**NORTH ANNA POWER STATION
IMPROVED TECHNICAL SPECIFICATION CONVERSION**

CHAPTER 2.0 - SAFETY LIMITS

Figure 2.1-1 REACTOR CORE SAFETY LIMITS FOR THREE LOOP OPERATION

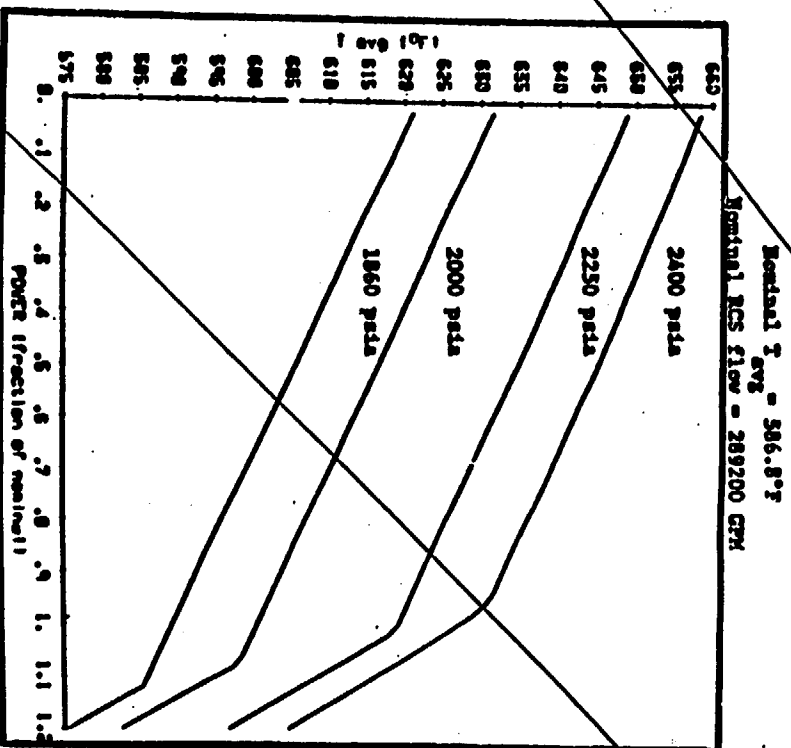
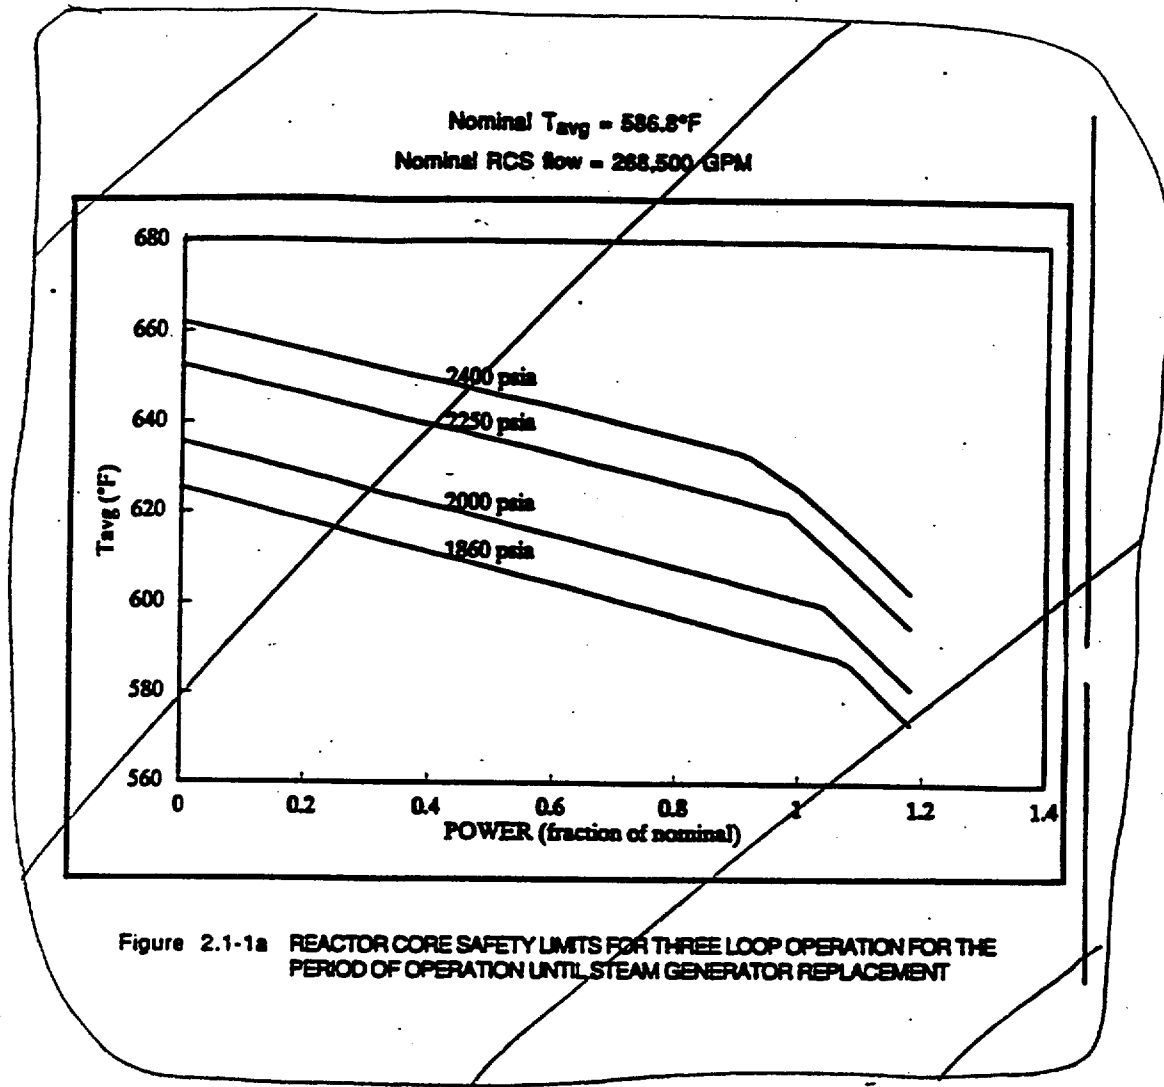
- A.2 CTS 2.1.1 references three curves providing limits on THERMAL POWER, pressurizer pressure, and the highest operating loop coolant temperature (T_{avg}). One curve applies to three loop operation (Figure 2.1-1) and two apply to two-loop operation (Figures 2.1-2 and 2.1-3). In the CTS, Figures 2.1-2 and 2.1-3 are replaced with a note stating, "This page left blank pending NRC approval of ECCS evaluation of two loops in operation with the third loop isolated" and "This page left blank pending NRC approval of ECCS evaluation of two loops in operation with the third loop not isolated," respectively. ITS 2.1.1 does not contain an allowance to operate with less than three reactor coolant loops in operation. This changes the CTS by eliminating references and place holders for curves applying to two-loop operation.

- LA.1 (*Type 5 – Removal of Cycle-Specific Parameter Limits from the Technical Specifications to the Core Operating Limits Report*) CTS 2.1.1 requires that the combination of THERMAL POWER, pressurizer pressure, and the highest operating loop coolant temperature not exceed the limits in CTS Figure 2.1-1. ITS 2.1.1 states that the combination of THERMAL POWER, RCS highest loop average temperature, and pressurizer pressure shall not exceed the limits specified in the COLR and provides specific limits on DNBR and peak fuel centerline temperature. This changes the CTS by relocating the reactor core SLs to the COLR with limiting parameters retained in the SL.

This change is acceptable because the requirements have not changed. Both the ITS and the CTS require all three loops in operation in the applicable MODES (MODES 1 and 2). This change is designated as administrative because it eliminates an option in the CTS which cannot be used.

The removal of these cycle-specific parameter limits from the Technical Specifications and their relocation into the COLR is acceptable because these limits are developed or utilized under NRC-approved methodologies. The NRC documented in Generic Letter 88-16, Removal of Cycle-Specific Parameter Limits From the Technical Specifications, that this type of information is not necessary to be included in the Technical Specifications to provide adequate protection of public health and safety. The ITS still retains requirements and Surveillances that verify that the cycle-specific parameter limits are being met. NRC-approved Topical Report WCAP-14483-A, "Generic Methodology for Expanded Core Operating Limits Report" determined that the specific values for the reactor core SLs may be relocated to the COLR. The reactor SLs continue to require that the core be operated within the SLs, and limiting values for the SLs continue to appear in the Technical Specifications. The methodologies used to develop the SLs in the COLR have obtained prior approval by the NRC in accordance with Generic Letter 88-16. Also, this change is acceptable because the removed information will be adequately controlled in the COLR under the requirements provided in ITS 5.6.5, Core Operating Limits Report. ITS 5.6.5 ensures that the applicable limits (e.g., fuel thermal mechanical limits, core thermal hydraulic limits, Emergency Core Cooling Systems limits, and nuclear limits such as SDM, transient analysis limits, and accident analysis limits) of the safety analysis are met. This change is designated as a less restrictive removal of detail change because information relating to cycle-specific parameter limits is being removed from the Technical Specifications.
